PZ&B Staff Combination Memorandum: Landmarks Preservation Commission and Town Council

SUBJECT: HSB-23-007 (ZON-23-095) 124 PARC MONCEAU (COMBO)

MEETING: FEBRUARY 21, 2024, LPC
MARCH 13, 2024, TC

The applicant has submitted plans, entitled "Addition and Renovation to Existing 2 Story Residence at 124 Parc Monceau", as prepared by **MP DESIGN & ARCHITECTURE** dated and stamped by the Town, January 16, 2024.

Proposed west rear elevation.

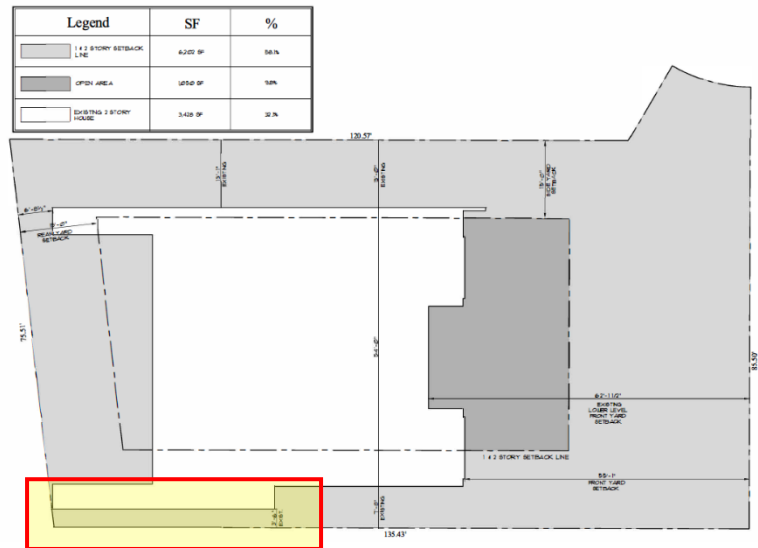
A preliminary review of the project, as proposed, appears to be inconsistent with the abovementioned sections of the Town zoning code. The application contains one (1) flood plain variance to be reviewed by the Landmarks Preservation Commission and one (1) site plan review for the nonconforming parcel to be reviewed by the Town Council. The application contains eight (8) zoning code variances for rear setback encroachment, side setback encroachment, lot coverage overage, landscape open space deficiency, elimination of a required garage parking space, and two (2) variances related to the height of site walls. The variances are triggered due to demolition of more than 50% of the rear elevation of the structure. The demolition is occurring at the lower basement level of the structure, the raised pool deck, and the rear loggia and balconies.

The project involves demolishing and reconstructing the rear pool, deck, and stair, altering the stair configuration to curve down towards the lake. Additionally, the covered loggias and balconies at the rear will be reconstructed with reduced projections and removal of second floor awnings. A new second-floor primary suite will be added over the center bay at the rear of the structure, featuring a flat roof with parapet and balustrade detail matching the entry portico. All exterior windows and doors will be replaced with Hartman products, designed to replicate Clarence Mack's original lite patterns. The garage doors will undergo replacement, with the north bay featuring a faux door with a window at the top center panel for the interior living space. Furthermore, landscape and hardscape improvements are proposed as part of the project.

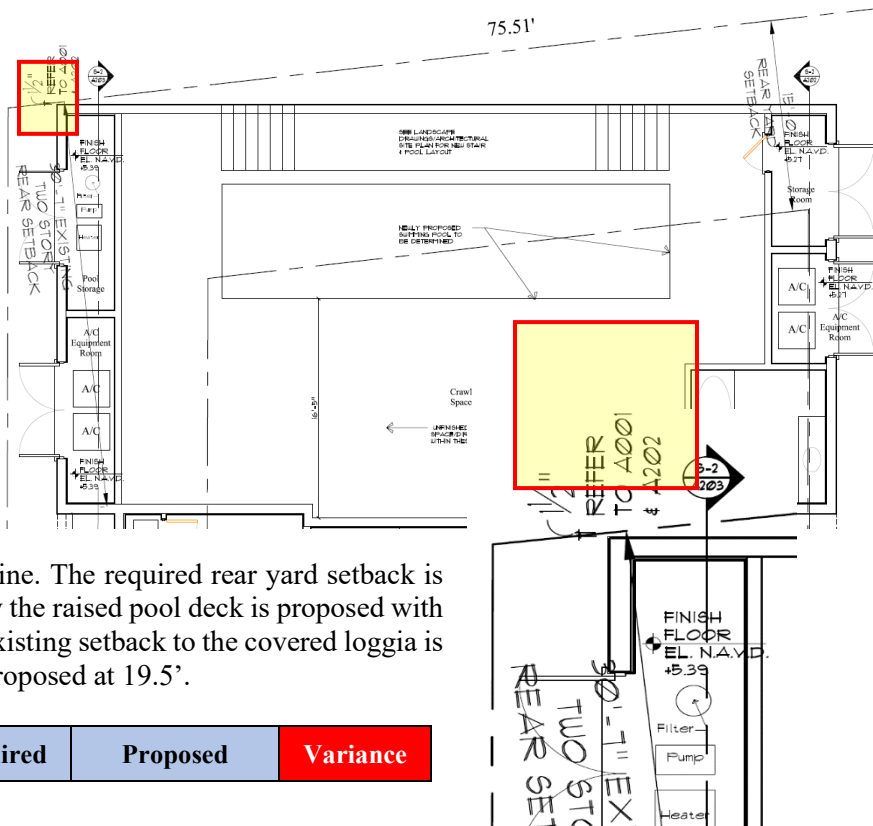
As it pertains to Variance 1, the applicant is proposing to retain the existing 3.5' side (south) yard setback. Currently, pedestrian tunnels lead from the basement under the rear pool deck at the north and south side of the structure. The elevated pool deck is being demolished and reconstructed due to structural deficiencies. Because of the demolition, the nonconformance is not permitted to be continued and a variance is required. The required side yard setback is 15' from the property line. The diagram to the right depicts the 3.5' setback area.

| Code Section | Required | Proposed | Variance |
|------------------------------------|-----------------------------|------------------------------|----------|
| VARIANCE 1: Sec. 134-843(a)(8): | Minimum side setback of 15' | Side (south) Setback of 3.5' | 11.5' |

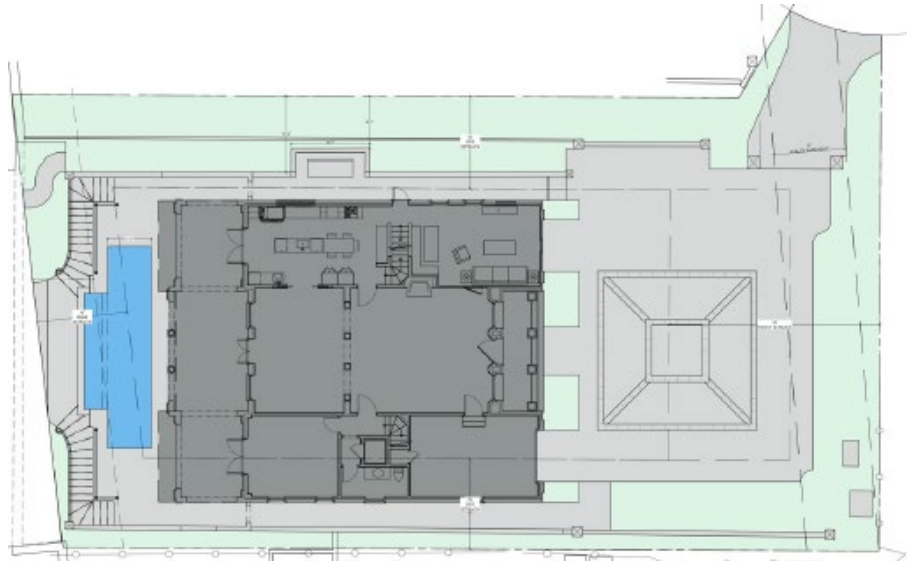
Variances 4 and 5 pertain to landscape open space minimums. Variance 4 to provide deficient overall landscape open space and variance 5 to provide deficient front yard landscape open space. Similar to the other variances, the existing landscape open space on site is already nonconforming at 30.2% provided overall, and 43.2% provided in the required front yard area. As a part of the proposed renovations to the site, the landscape open space is improving, with 10% additional landscape open space being added, however, it still under the minimum requirements; as such, variances are required. The proposed landscape open space diagram is shown above.

| Code Section | Required | Proposed | Variance |
|---------------------------------------|--|--|----------------------------|
| VARIANCE 4: Sec. 134-843(a)(12)(a) | Minimum Overall Landscape Open Space of 50% | Overall Landscape Open Space of 30.2% (in lieu of 20.6% existing). | 19.8% Under Minimum |
| VARIANCE 5: Sec. 134-843(a)(12)(b) | Minimum Front Yard Landscape Open Space of 45% | Front Yard Landscape Open Space of 43.2% (in lieu of 36.9% existing) | 1.8% Under Minimum |

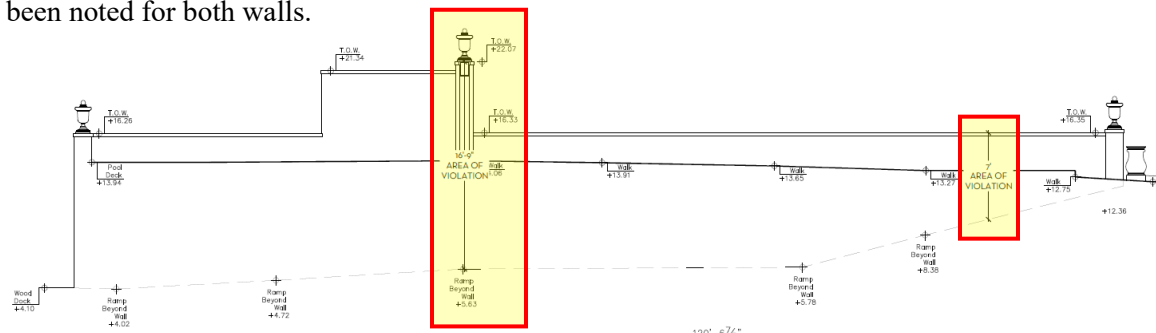
Variances 7 and 8 pertain to perimeter site wall heights. The parcel has a significant change in grade, sloping downwards towards the Lake Worth Lagoon. The significant change in grade has created an existing condition where the height of site walls varies greatly. On the north, the grade starts at roughly 12' NAVD and slopes all the way down to almost 4' NAVD at the west on the pedestrian ramp. On the south, the grade starts at roughly 12.5' NAVD on the east and works its way down to about 3.5' NAVD at the west property line. With the combination of the changes in grade and the height of the walls being raised to provide privacy for the subject parcel, variance requests are required. Staff notes that the grade condition is existing on site. The extremities occur at several different points across the span of the walls, so for clarity the least expanse of variance and the greatest wall high increase have been noted for both walls.

| VARIANCE 8: Sec. 134-1669 | Maximum Wall Height of 7' | Varying wall height of 10.67' to 15.33' at south | 3.67'to 8.33' higher. |

SITE PLAN REVIEW

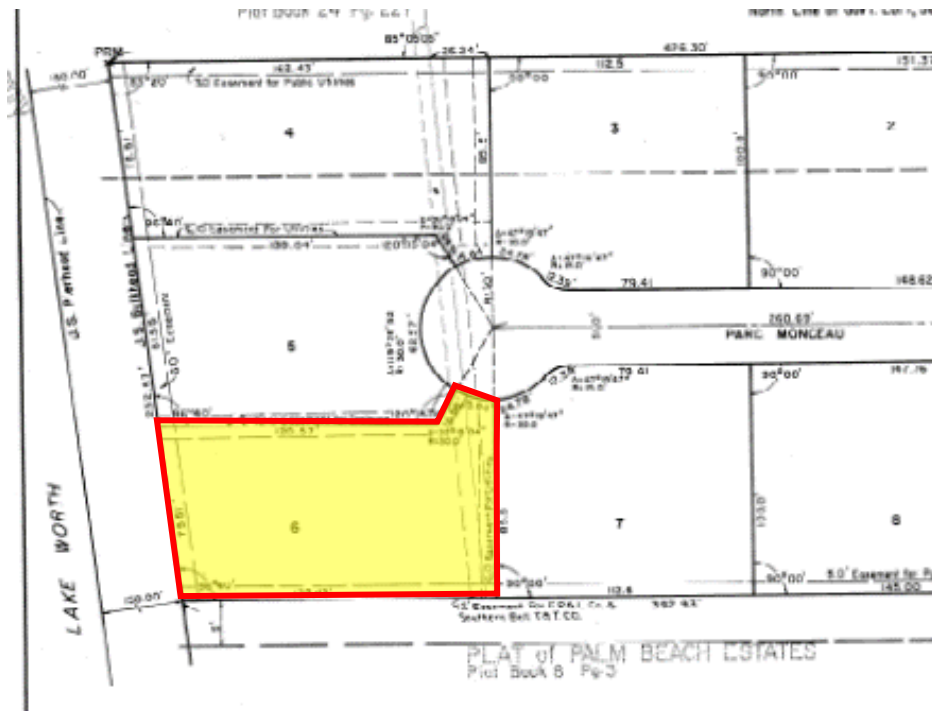
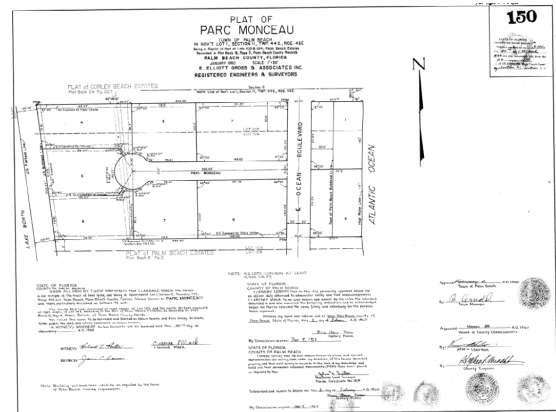
As it pertains to the request for Site Plan Review, development of nonconforming parcels of land must be reviewed by the Town Council. As this lot is comprised of a single platted lot (Parc Monceau Lot 6) in the subdivision, only Site Plan Review by Town Council is required. The existing irregularly shaped lot is 75.51' in width (in lieu of the 125' required), 135' in depth (in lieu of the 150' required) and 10,722 square feet in area (in lieu of the 20,000 square feet required). Because of the loss of more than 50% of an elevation as part of the renovation, approval of the development the existing nonconforming improved site must be revested.
